Delegated officer report for planning application

Application no. 134630/LP/2022

Proposal: Roof alterations involving hip to gable extension and rear roof dormer.

Address: 45 Brantwood Terrace, Manchester, M9 4LR

Image 1 Taken from OS Map dated 1951

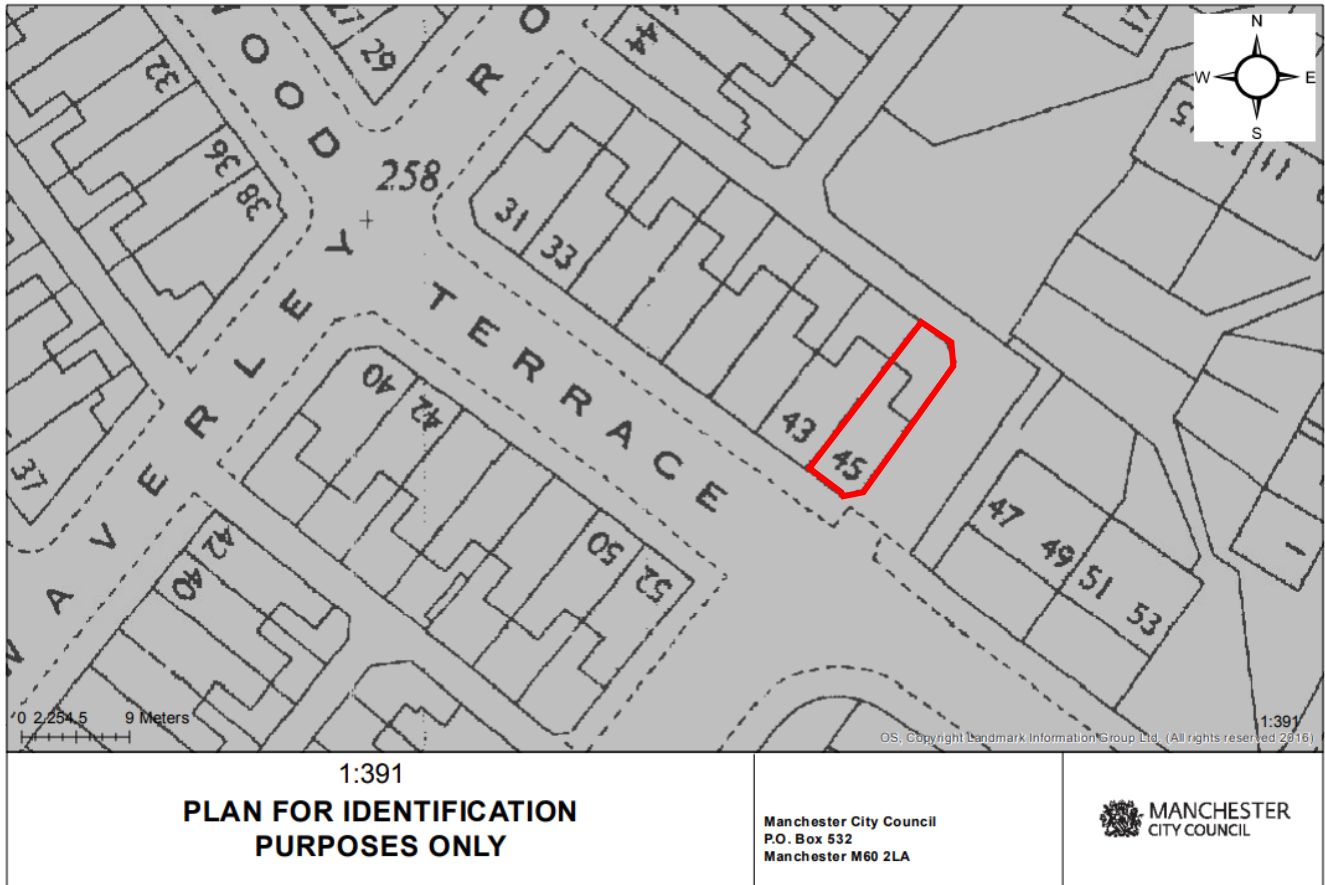
Complies [✓] The cubic content of the proposed dormer would exceed 40 cubic metres as demonstrated below:

Height (metres)	1.988	Total Volume: 16.74
	Depth (metres)	4.077	
	Length (metres)	4.130	
	Calculate Volume Reset

The hip to gable volume = 19.87 cubic metres.

The cubic content for the dormer and hip to gable would be **36.61 cubic metres**, however as noted the property has been extended with a single storey rear extension to the existing outrigger which has a cubic content of **2.60 cubic metres** taking into account that the original outrigger (see o.s map image 1) occupied half the width of the original rear elevation. Therefore, the total enlargement would be **39.21 cubic metres**.
